Re Request for review of the request for registration for the CDM project activity “GHG emission reduction by energy efficiency improvement of clinker cooler in cement manufacturing at Rajashree cement at District Gulbarga, Karnataka India” (Ref. no. 0954)

Request for Review:

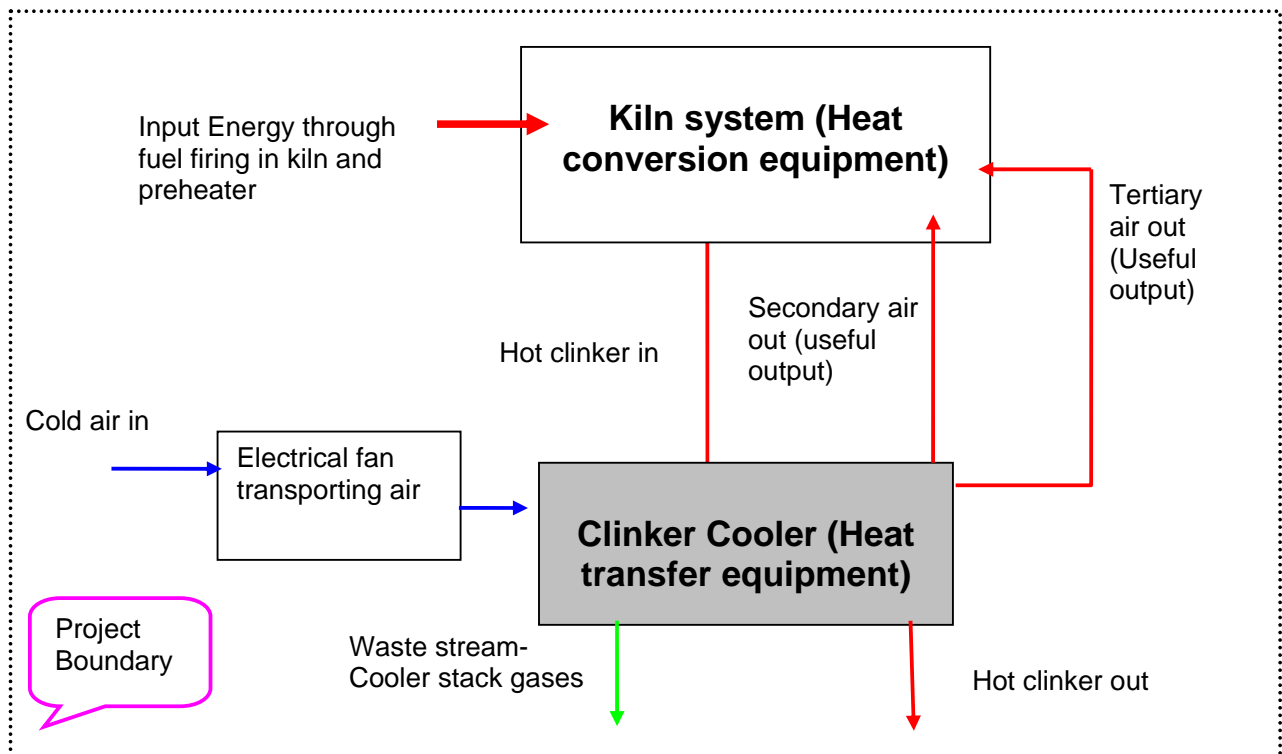
1. This project activity uses AMS II D which is a generic methodology for energy efficiency. The same technology was submitted as large scale methodologies NM0101 and NM0154 for energy efficiency in clinker cooler, both of which were given a C by the Meth Panel. It should be assessed whether AMS IID is correctly applied to this project.
2. We have now seen several project activities that present this issue. The Board may wish to ask the SSWG to review whether the concerns expressed by the Meth Panel with respect to the above not approved large scale methodologies need to be addressed by AMS II D.
3. It should be clarified if the project meets the small scale criteria (the sum of the size of the technology applied being above the 45 MWthermal limit suggest it is not).

Based on the number of parameters the calculation may look complex but it is simple based on institutional as well as industrial standards.

Heat Balance Approach - In the project activity all the parameters used are continuously monitored parameters and the quality of products depends on those parameters. The project proponent is reputed cement manufacturer and has its brand value and produces consistent quality of product. For the consistent quality, the parameters will be more or less within the acceptable range of variations. The approach adopted is same for baseline and project scenario and the small variations are averaged out in determination of baseline efficiency. In this manner the calculation performed in the project activity will be as per the established practice in cement sector and will be within the acceptable variation.

The project is metering the energy use of the equipment affected by the project activity. By increasing the efficiency of the clinker-cooler, the kiln fuel input is affected hence the monitoring of the clinker-cooler and the kiln fuel input is necessary as per the methodology (Please refer to the diagram below). However, the emission reduction is calculated based on the fuel emission factor (tCO₂/TJ) and energy saved due to increase in the clinker-cooler efficiency. This approach avoids the claim of any emission reduction due to kiln modifications itself and considers the benefits from clinker-cooler efficiency only.
